Subject: **Response to Portion of NRC Request for Additional
Information Letter No. 38 Related to ESBWR Design
Certification Application – Structural Analysis – RAI Number
3.8-4 S02**

1. MFN 06-298, Supplement 4 – Response to Portion of NRC Request for Additional Information Letter No. 38 Related to ESBWR Design Certification Application – Structural Analysis – RAI Number 3.8-4 S02

Structural Analysis – RAI Number 3.8-4 S02¹

Figure 3.8-4 (1) Comparison in M-N interaction between ACI 349-01 and ASME 2004-Section III, Division 2

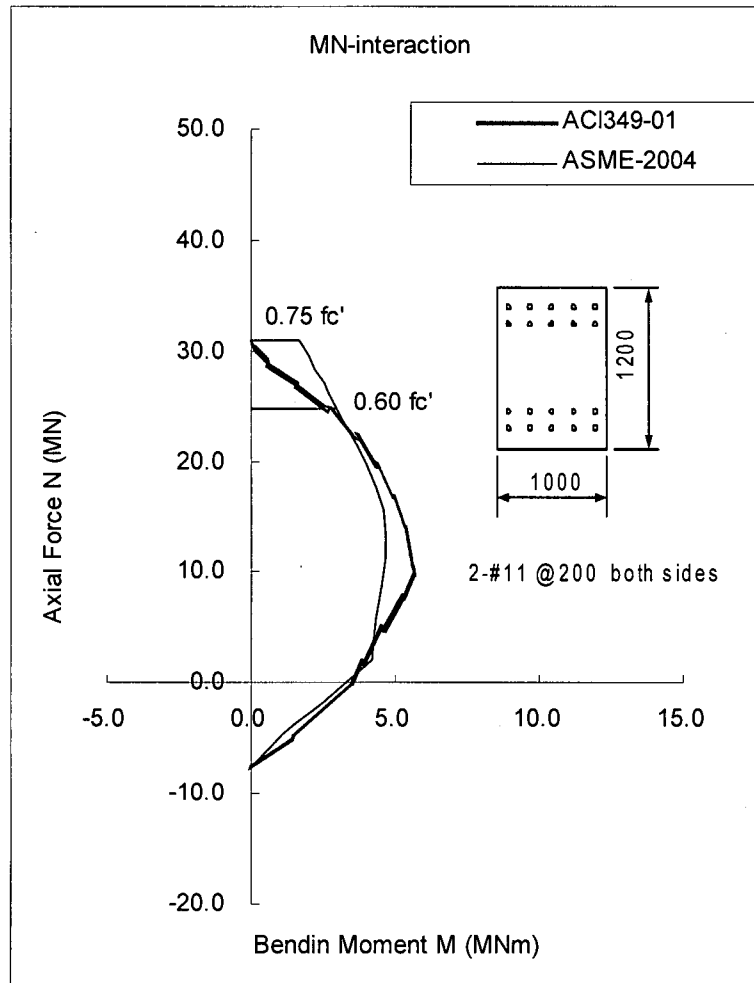
During the audit, GE explained that the loads and load combinations for the entire RB from the ACI 349 and ASME Section III, Division 2 are checked against the acceptance criteria in ASME Section III, Division 2 Code. GE indicated that they have confirmed that the acceptance criteria in the ASME, Section III, Division 2 Code are more conservative than the acceptance criteria in ACI 349. GE was requested to provide the technical basis for this conclusion. Therefore, in effect the entire RB is designed to both the ASME Section III, Division 2, Subsection CC and the ACI 349 Code. In this case, the current boundary shown in DCD Figure 3.8-1 for the ASME jurisdictional boundary for all aspects of design, construction, fabrication, and inspection is acceptable. GE will provide a supplemental response to this RAI and RAIs 3.8-67, 101, 102 and 103 to reflect the above.

Figure 3.8-4 (1) shows the comparison of M-N (bending moment-axial force) interactions that define the relationships between allowable bending moments and axial forces calculated in accordance with ACI 349-01 and ASME 2004 Section III, Division 2 codes (for factored primary and secondary loads).

As shown in Figure 3.8-4 (1), the ASME allowable values are smaller, except in the high axial force (compression) region in which the ASME limit is $0.75f'_c$ for primary plus secondary membrane and $0.60f'_c$ for primary membrane. For additional conservatism,

the $0.60f'_c$ limit, which is lower than the ACI 349-01 allowable, is applied to the ESBWR design. Therefore, the use of the ASME acceptance criteria is a conservative design approach for the design of ESBWR concrete structures that are integrated with the containment.
